H. B. ROBINSON STEAM ELECTRIC PLANT, UNIT NO. 2

RESPONSE TO REQUEST FOR ADDITIONAL INFORMATION -
EXTENSION OF OPERATING LICENSE (TAC NO. 66079)

RESPONSE TO REQUEST FOR ADDITIONAL
INFORMATION FOR THE EXTENSION OF
THE OPERATING LICENSE FOR
H. B. ROBINSON STEAM ELECTRIC PLANT, UNIT 2

TABLE 9.1
RADWASTE VOLUMES (ft³)

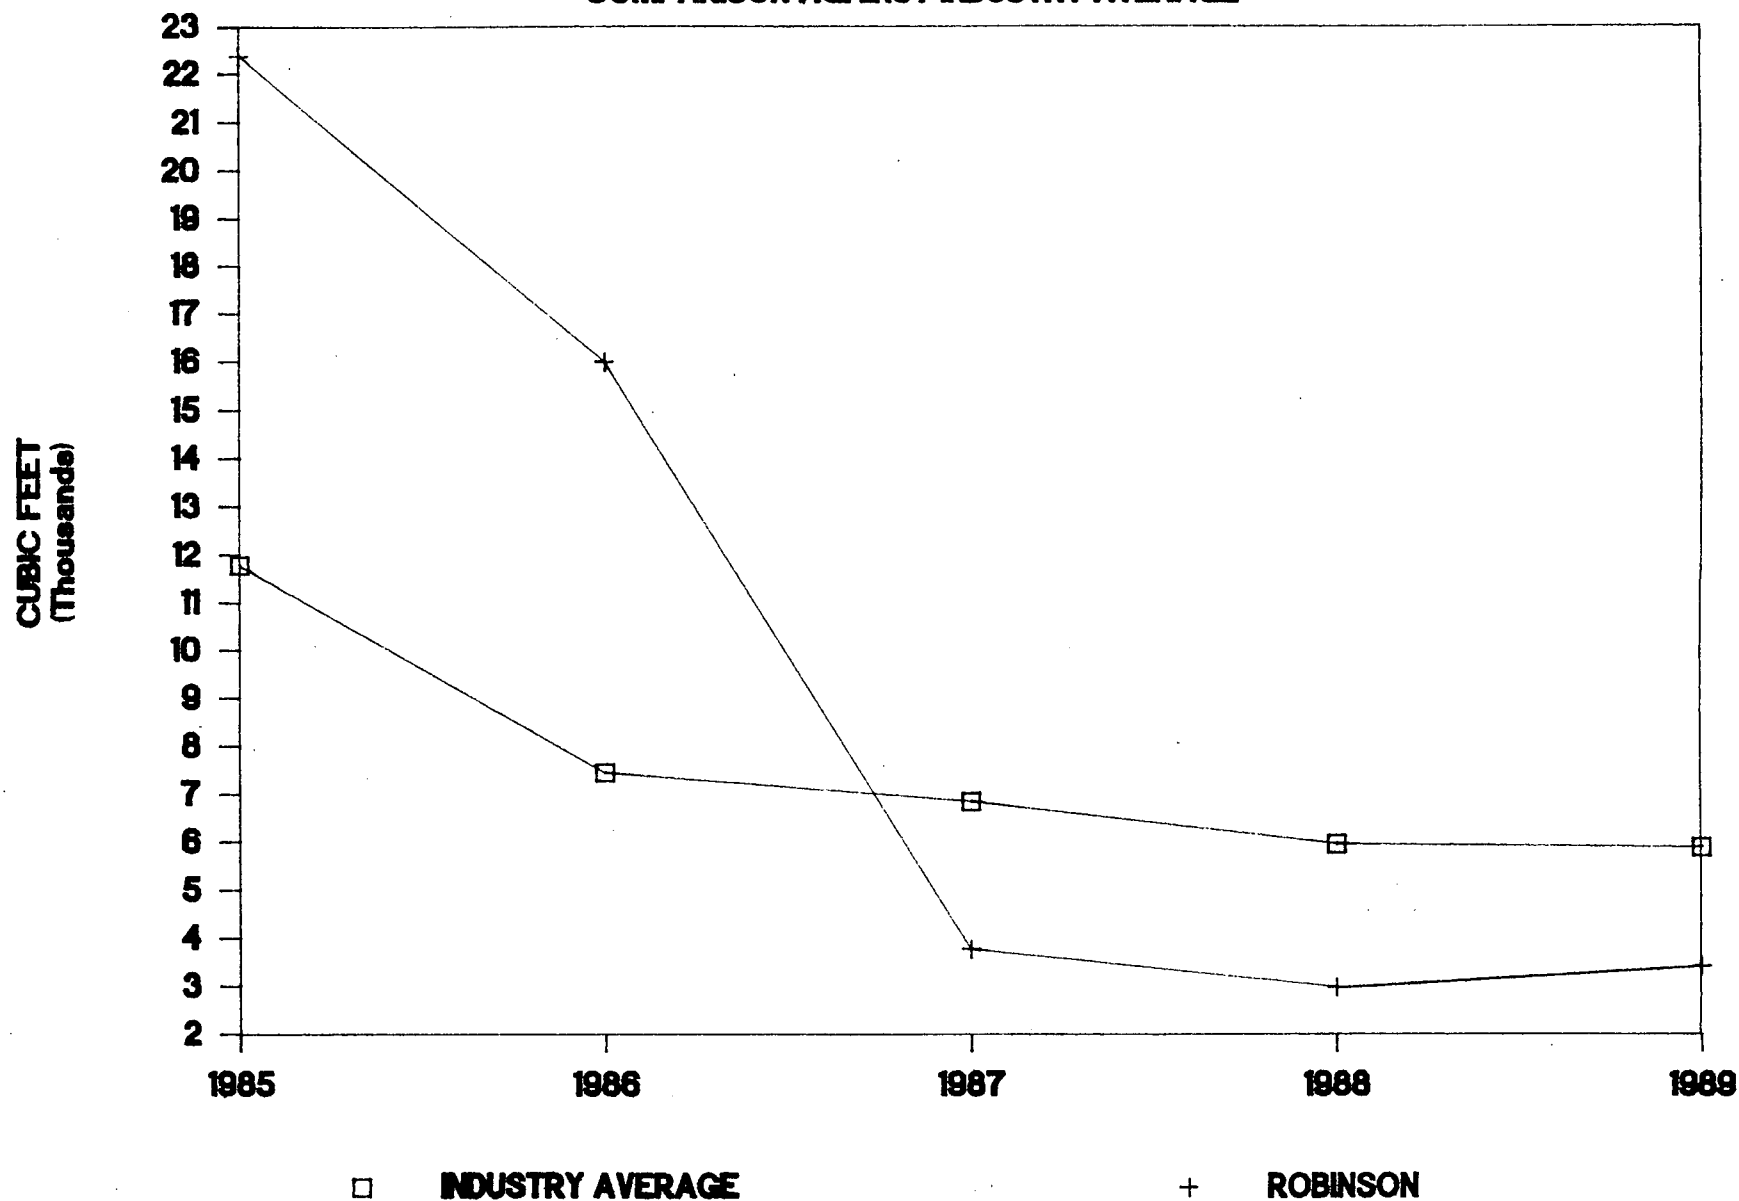
9. *Provide a comparison between actual radwaste shipments in recent years and the information provided in FES section 11.1.7, and estimate the impact for the extension periods.*

The FES for the H. B. Robinson Nuclear Project, Section 11.1.7, discusses the anticipated volumes of solid radioactive waste generation associated with the operation of the facility. The original projections estimated that approximately 500, 55 gallon drums of wet solid wastes (spent demineralizer resins, filter sludges, and evaporator bottoms) would be generated and shipped annually. In addition, approximately 450, 55 gallon drums of dry solid wastes (ventilation air filters, contaminated clothing, paper and miscellaneous other items) would be generated and shipped annually. This equates to a total of 950, 55 gallon drums or approximately 7125 ft³. Currently, the facility no longer generates liquid concentrates and has switched to an in line demineralization system for radwaste processing in an effort to minimize solid radwaste generation.

During the past five years of operation the facility has made tremendous progress in reduction of radwaste volume. While the facility's solid radwaste volume had at one time been greater than projected by the FES (partially due to solid wastes generated as part of the steam generator replacement outage), it has been reduced well below this value and has also been well below the industry average as defined by the Institute for Nuclear Power Operations (INPO). Table 9.1 provides the total solid radwaste volume in cubic feet produced per year for the past five years of operation along with the industry average for PWR's for the past five years. As shown in this table, the H. B. Robinson Nuclear Project has been well below the industry average for the past three years. Based on the volume produced to date this year, it is expected that 1990's radwaste volume will also be well below the industry average. CP&L is continuing to actively pursue additional volume reduction techniques such as incineration of dry active wastes and resin oxidation. In addition, CP&L is also pursuing source term reduction techniques such as cobalt elimination which, in addition to volume reduction, will likely produce a reduction in radwaste activity.

Based on this information, it is expected that annual average waste volumes will continue to remain below the original projections of the FES and that solid radwaste production of the facility will continue to be reduced as new technologies become available. The expected solid radwaste generation for the years of requested license extension will be a small fraction of the total generated over the facilities lifetime. This volume is not considered to be significant and will not alter the conclusions of the FSAR or the FES.
